SUBJECT: **Customer Satisfaction Program 21N01 - Supplement #2**
 Certain 2016-2018 Model Year Explorer Vehicles
 High-Speed Cooling Fan Motor Relay

REF: **Customer Satisfaction Program 21N01 - Supplement #1**
 Dated: December 16, 2021

New! REASON FOR THIS SUPPLEMENT

CERTAIN 2016-2018 MODEL YEAR EXPLORER BJV VEHICLES — HIGH SPEED COOLING FAN MOTOR RELAY

FIGURE 1

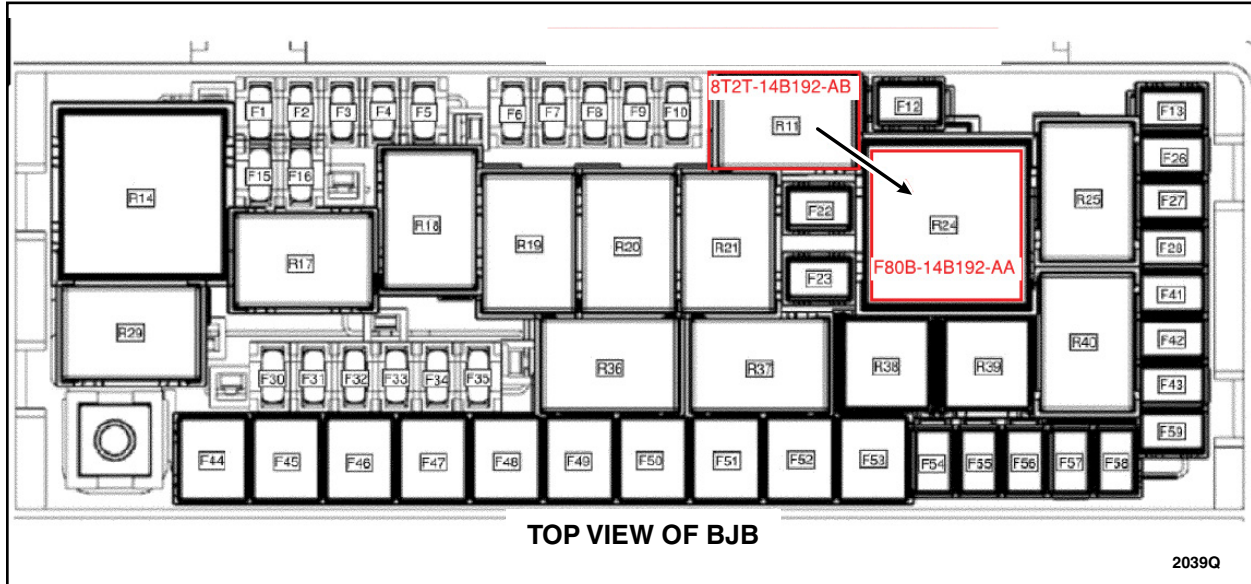
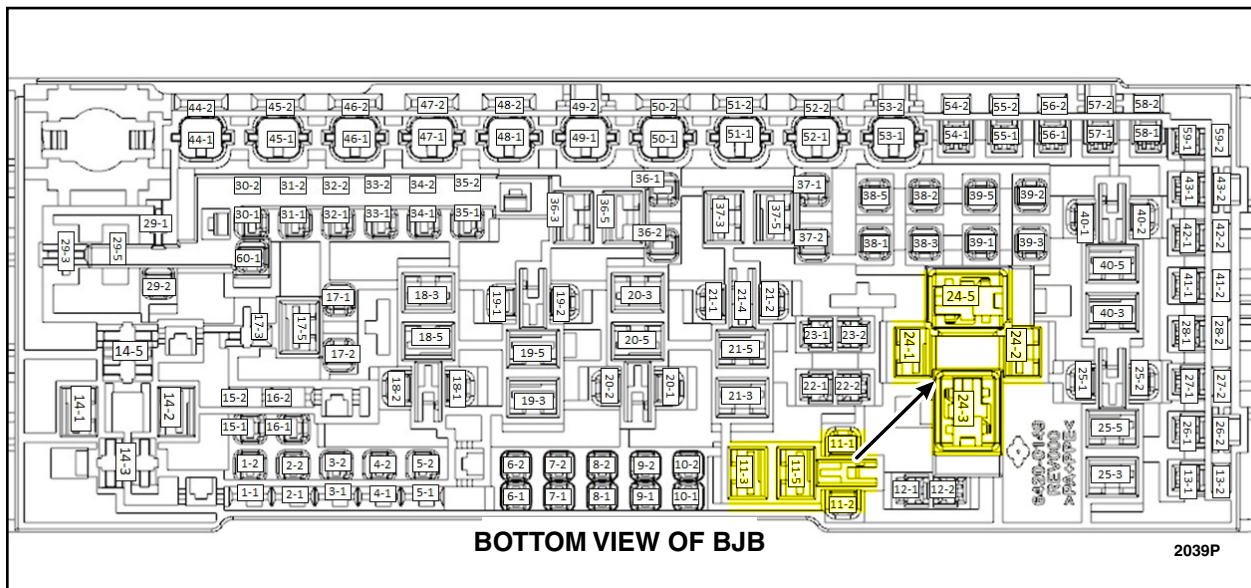
NOTE: The high speed cooling fan relay (R11) will be relocated to the (R24) position in the Battery Junction Box (BJB) as shown in Figures 1 and 2.

FIGURE 11

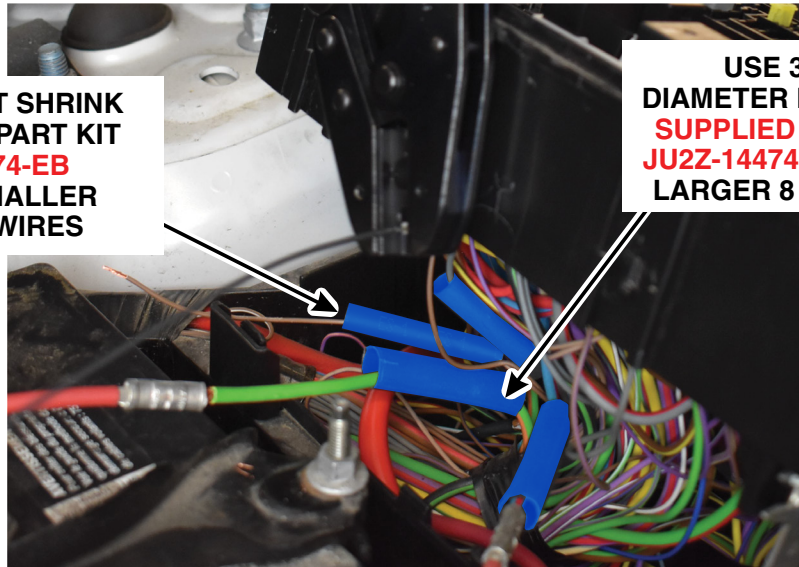
- NEW !** 9. Replace the terminal ends on the four (4) R11 wire terminals that were removed in Steps 7 and 8 using the directions below:

⚠ WARNING: Cover battery to avoid contact to terminals which could damage the Powertrain Control Module (PCM).

- e. Install heat shrink with **lined adhesive**:
 1. On the harness side, install a piece of two inch long, 0.38 in. (9.53 mm) diameter, heat shrink tubing over both larger 8 AWG wires.

2. Then, install a piece of heat shrink tubing, supplied with Part Number **KU2Z-14474-EB**, over both smaller 10-12 AWG wires.
 3. Slide all four (4) heat shrink tubes away from the heat while soldering. See Figure 11.

USE THE HEAT SHRINK SUPPLIED IN PART KIT **KU2Z-14474-EB** FOR THE SMALLER 10-12 AWG WIRES

USE 3/8 INCH DIAMETER HEAT SHRINK SUPPLIED IN PART KIT **JU2Z-14474-BC** FOR THE LARGER 8 AWG WIRES

FIGURE 12

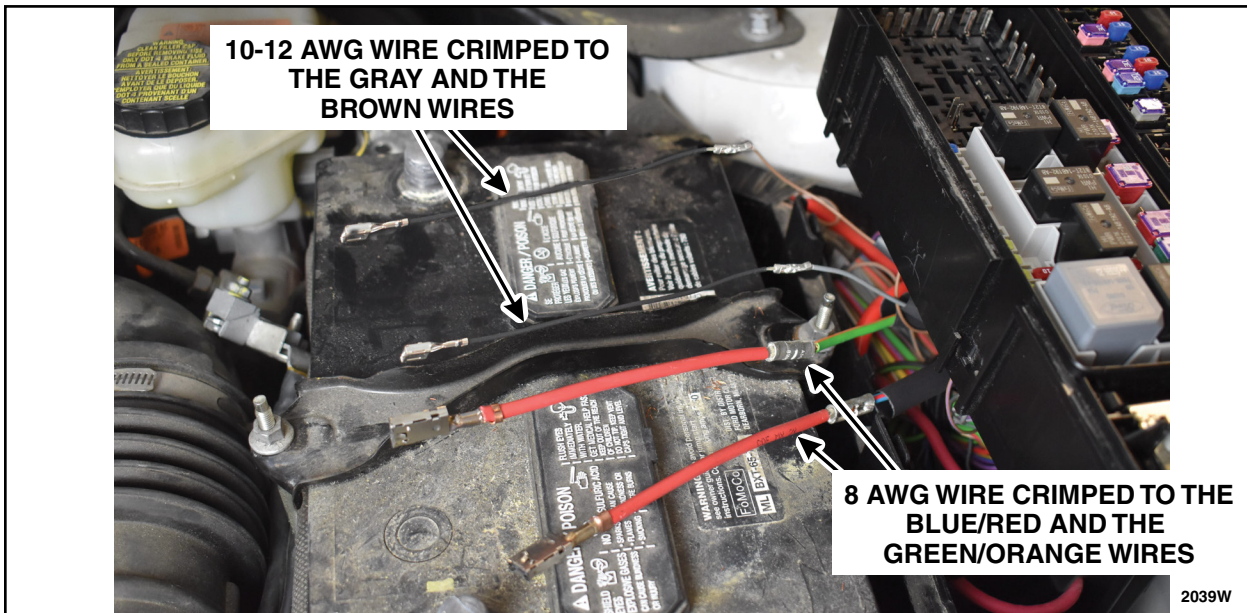
⚠ WARNING: Cover battery before splicing.

10-12 AWG WIRE CRIMPED TO THE GRAY AND THE BROWN WIRES

8 AWG WIRE CRIMPED TO THE BLUE/RED AND THE GREEN/ORANGE WIRES
